File Name	Prepared by	Reviewed by	Issued by	Date	Issued to
P2588.001T 230 Victoria Road, Gladesville TIA Review	C. Wills	SP. Power	SP. Power	27/05/2016	Sandra McCarry, City of Ryde

230 Victoria Road, Gladesville TIA Review

Bitzios Consulting has been engaged by the City of Ryde to undertake an independent peer review of the traffic and parking components of a proposed mixed use development located at 230 Victoria Road, Gladesville. The development site is shown in Figure 1.1. The proposal includes:

Figure 2.1: Examples of Obstructions Located Too Close to Parking Spaces

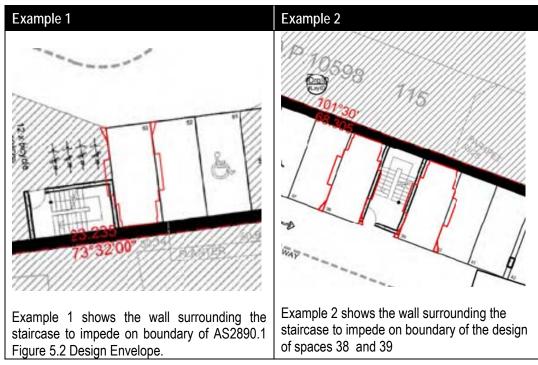
Fifteen parking spaces have been found to have walls or obstructions that impede the opening of doors, estimated by the placement of the design envelope specified AS2890.1 Figure 5.2. This design envelope requires a 300mm clearance either side of the vehicle where the doors are. Examples of this type of non-compliance are shown in Figure 2.1Error! Reference source not found.. A number of walls, lift-shafts and columns breached this envelope on the following spaces which require alteration:

DA2102 Issue A (Ground Floor):

- Space 1 (Visitor)
- Space 8 (Visitor)

DA2101 Issue A (Basement 01):

- Space 1 (Residential)
- Space 38 (Residential)
- Space 39 (Residential)

DA2100 Issue A (Basement 02):

- Space 1 (Residential)
- Space 8 (Residential)
- Space 9 (Residential)
- Space 10 (Residential)
- Space 16 (Residential).

- Space 20 (Commercial)
- Space 25 (Visitor)
- Space 53 (Residential)
- Space 72 (Residential)
- Space 73 (Residential)

Figure 2.2: Location of Parking Spaces Requiring Swept Path Analysis to Confirm Compliance

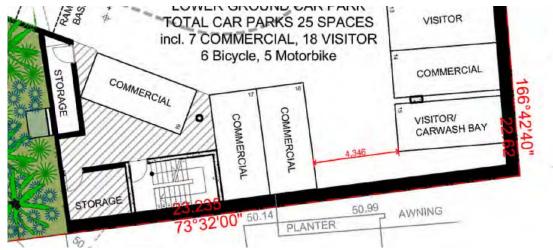
- Three parking spaces in *DA2102 Issue A* have been identified as difficult to access, requiring swept path analysis for a B85 vehicle. These spaces are shown in Figure 2.2 and described below:
 - Parking space 14 (commercial) and 15 (visitor/car wash): The architectural drawings show an aisle width of 4346mm, below the required 5800mm. Egress from these spaces would require a reverse manoeuvre into an oncoming traffic stream.
 - Parking Space 19 (Commercial): access to the parking space will require a reverse parallel park manoeuvre, impeded by a bollard (400mm to the east) and the walls of the adjoining storage. It would also block pedestrian access to the stairs at the exterior wall.

Figure 2.5: Non-Compliant Aisle Width

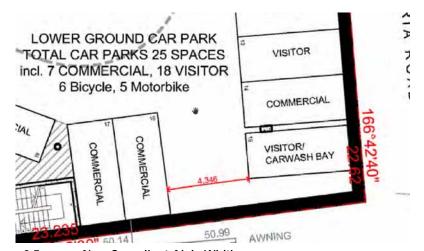
The aisle width shown for the commercial parking space #14 and visitor/carwash bay #15 is short of the required 5800mm as shown in Figure 2.5. This is required to be amended to comply with AS2890.1.

Figure 2.6: Service Truck Maneuvering

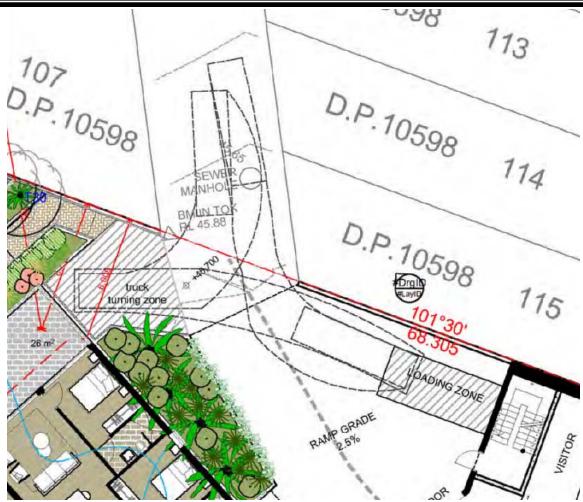
It is proposed for council service vehicles, up to and including the council's 7.5m garbage truck, to enter the site and access the sites waste and loading areas located on the lower ground floor level (*DA 2101 Issue A*). The manoeuvring of a truck is shown below in Figure 2.6, and although Varga Traffic Planning state that this vehicle is the councils 7.5m garbage truck the vehicle is not labelled and cannot be confirmed.
